SUBJECT: Forwards Bechtel Power Corp responses to outstanding open items of Class IE dc power sys review. Responses are intended to resolve outstanding concerns of DC Power Sys Review Board. Final resolution of open items will be provided.

Subject: Palo Verde Nuclear Generating Station  
PVNGS Units 1, 2 and 3  
Docket Nos. STN-50-528/529/530

ADDITIONAL CLARIFICATION  
REGARDING DC POWER SYSTEM REVIEW

Figure 2 -7-

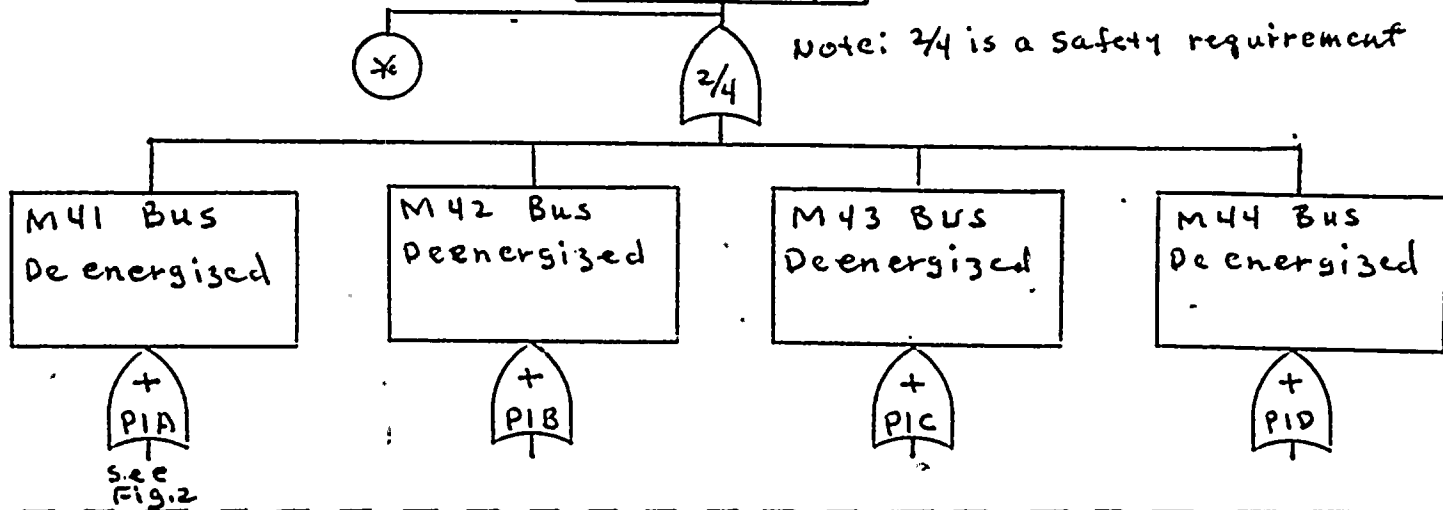
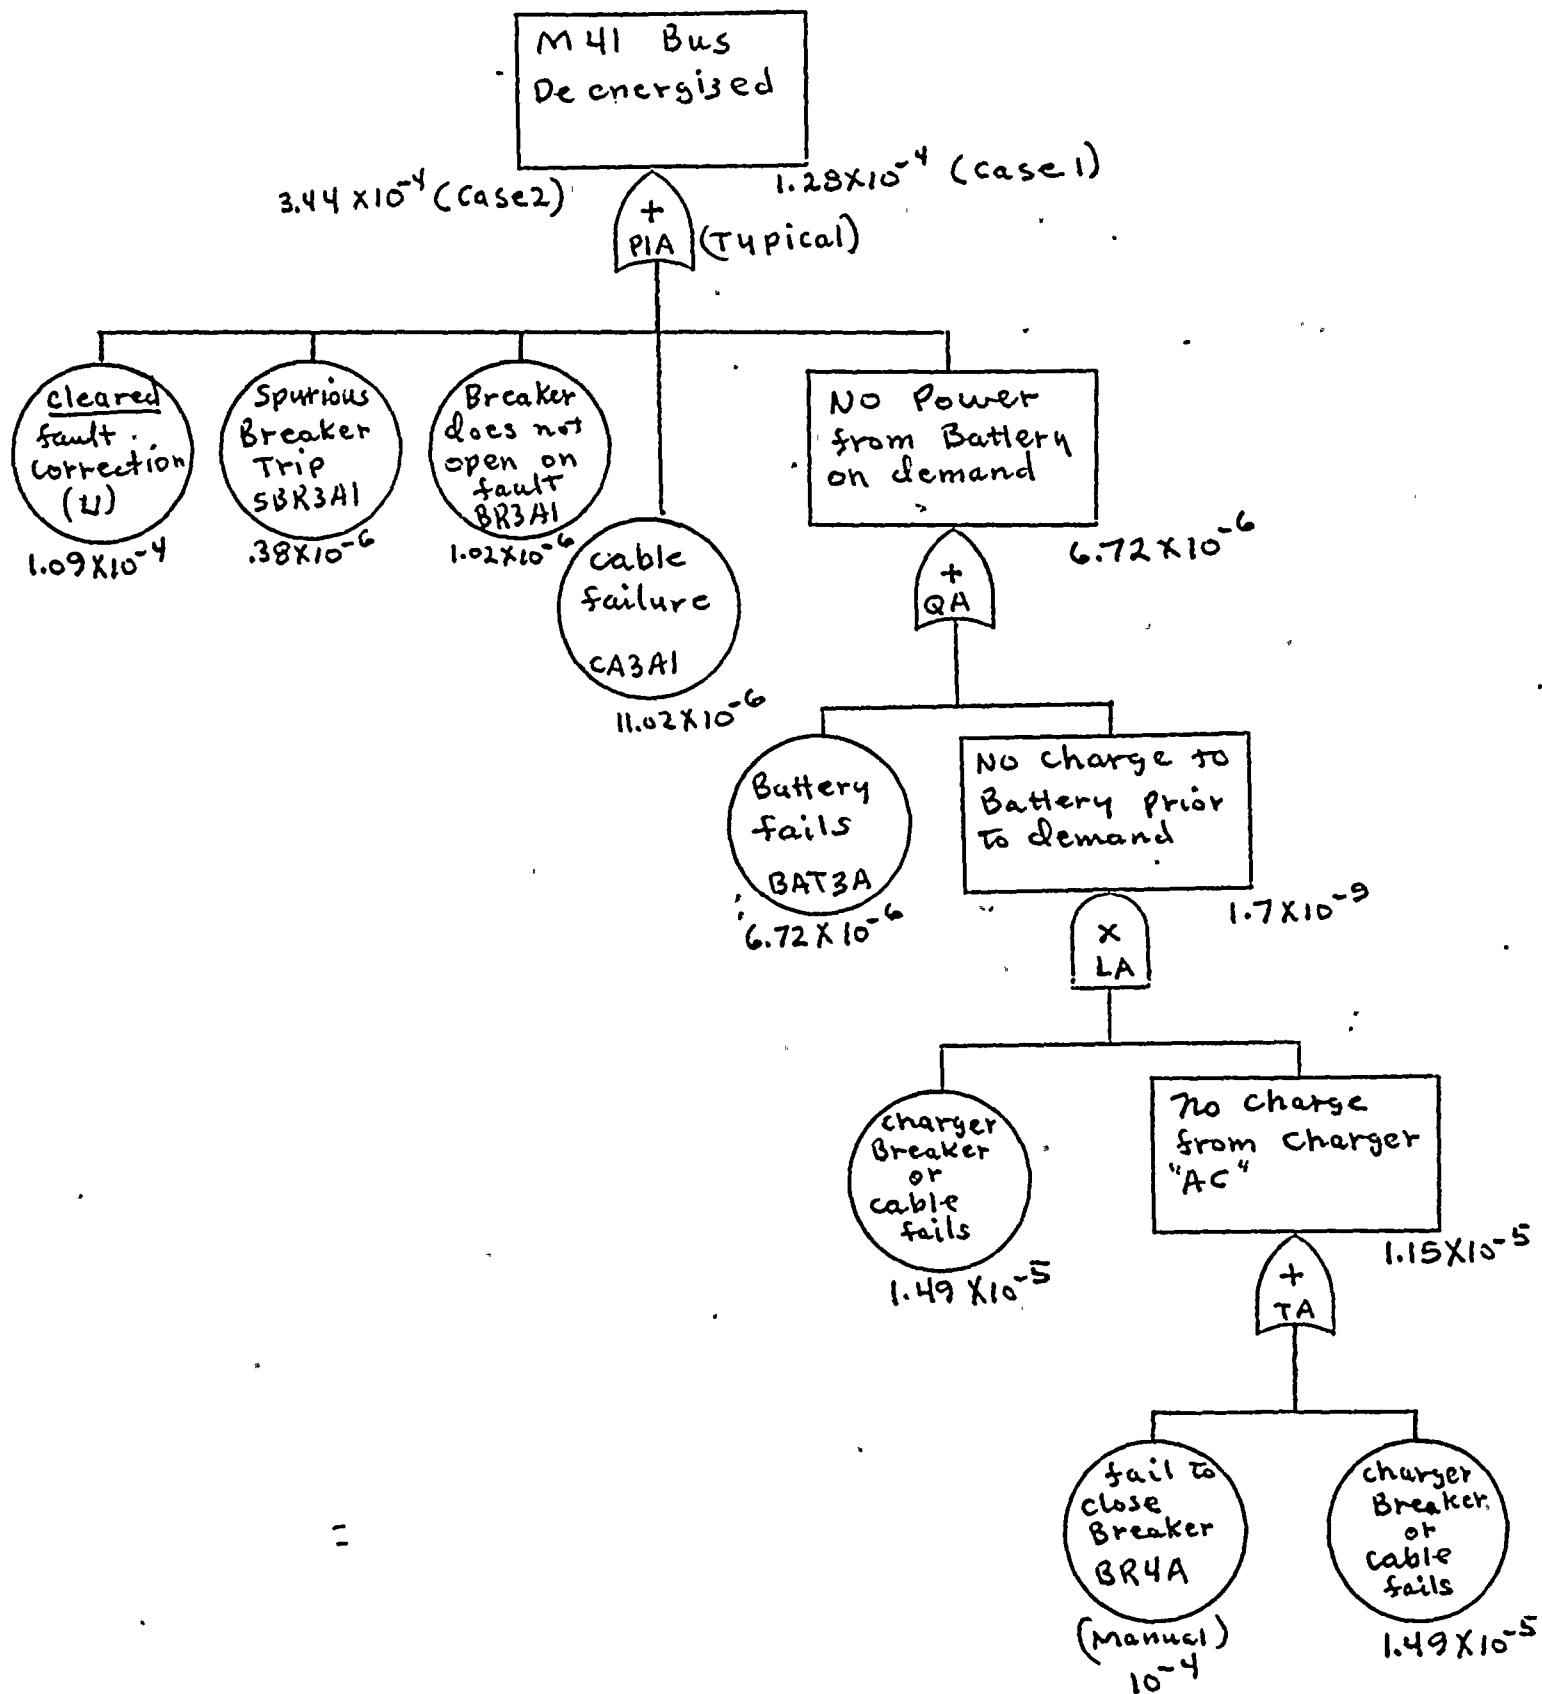
Bechtel has misinterpreted the original question. Please respond to the question as expanded upon below.

- (A) The necessity of thermal or magnetic trips on the battery to bus disconnect device should be determined. Since the battery must be most reliable and the chance of a fault occurring on the main D.C. bus is considered very remote, the necessity of tripping devices on this breaker is questioned when reliability and security of control is of extreme importance.

(A) A reliability analysis of the DC system was conducted in order to disclose any differences in reliability that may exist between the present design having an air circuit breaker on the battery versus a hard wired battery to bus version. The analysis was conducted assuming station AC blackout. The reliability analysis was performed on an overall system basis with system failure defined as loss of 2 out of 4 channels.

One difference noted is the time required to clear a fault, since the system is unavailable to respond to a loss of all AC during the fault correction time. An 8 hour fault correction time was assumed for the battery breaker case and 24 hours was assumed for the hard wired case (due to battery damage). Battery damage in the event that the battery breaker failed to open was also considered. One hour was assumed as the time required to reset a breaker.

The results of the analysis are shown in Table 2. The fault trees used in the analysis are also attached as Figures 1 and 2.

The results indicate that, given the assumptions discussed above, case 2, the air breaker on the battery, is slightly more reliable. Therefore it is recommended that no changes be made to the present system design.
